Spring Park P6

Rebuttal to Landscape Technical Note by Ecology Solutions Ltd on behalf of Rangeford Villages

edp7897_r010a

Image EDP 4.1: Extract from Google Earth showing PVP EDP 15

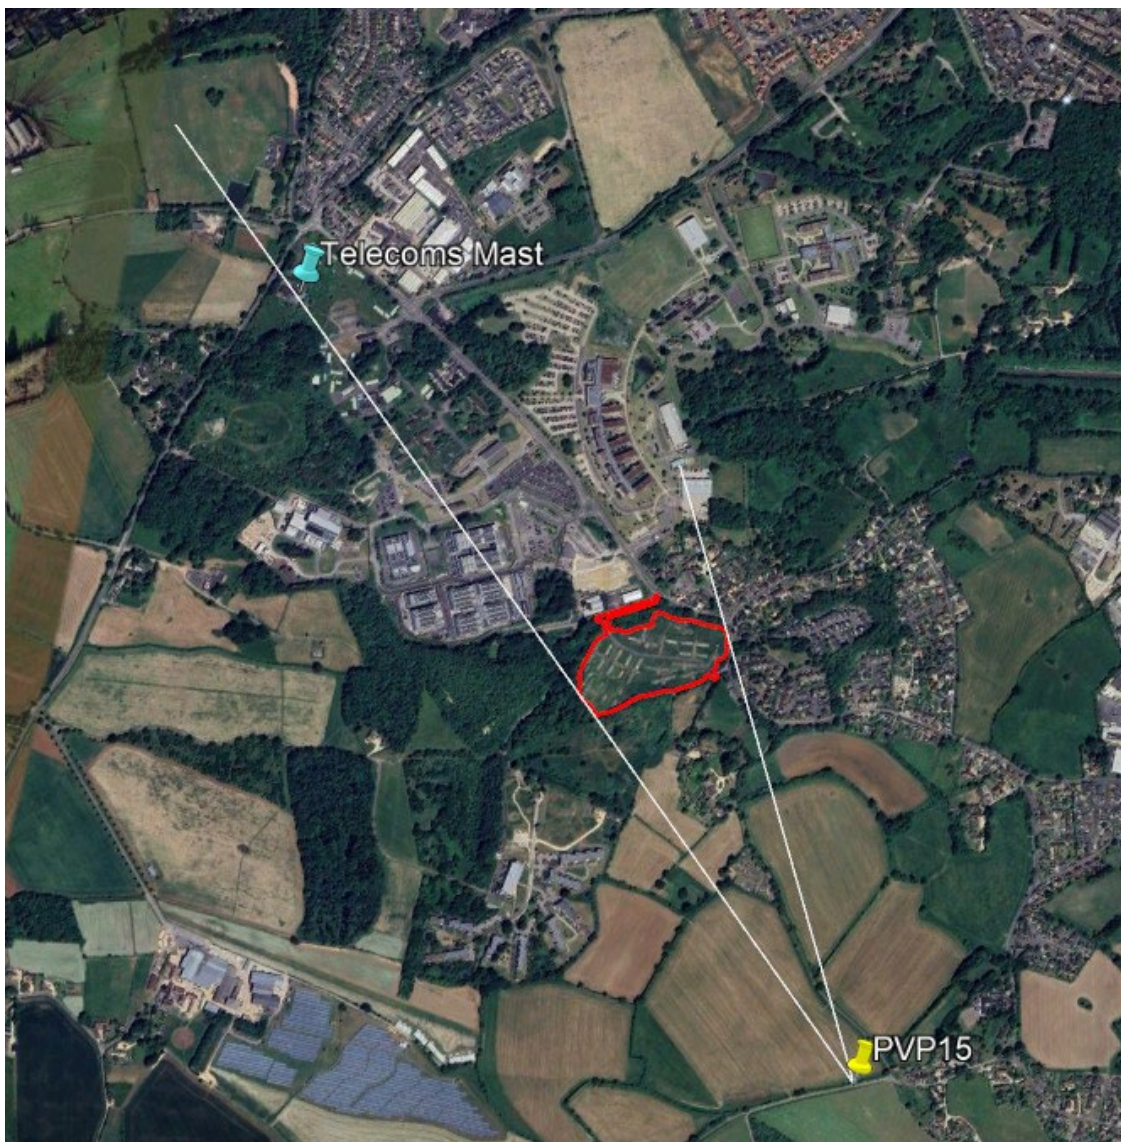
- 4.3 Paragraph ES 1.13: The extents of the Site marked on the PVP represent the area proposed for the built form of the Proposed Development, rather than the wider landscaping and Biodiversity Net Gain (BNG) areas (which would not be readily visible). It is acknowledged that the marked extents should extend very slightly further towards the telecoms mast – see **Image EDP 4.1**.

- 4.4 The parts of the overall site closer to the Wadswick Green development are all proposed for landscape enhancements and BNG so would not be readily visible.
- 4.5 **Image EDP 4.1** does also clearly show the prominence of the concrete footings and roadways within the Site.
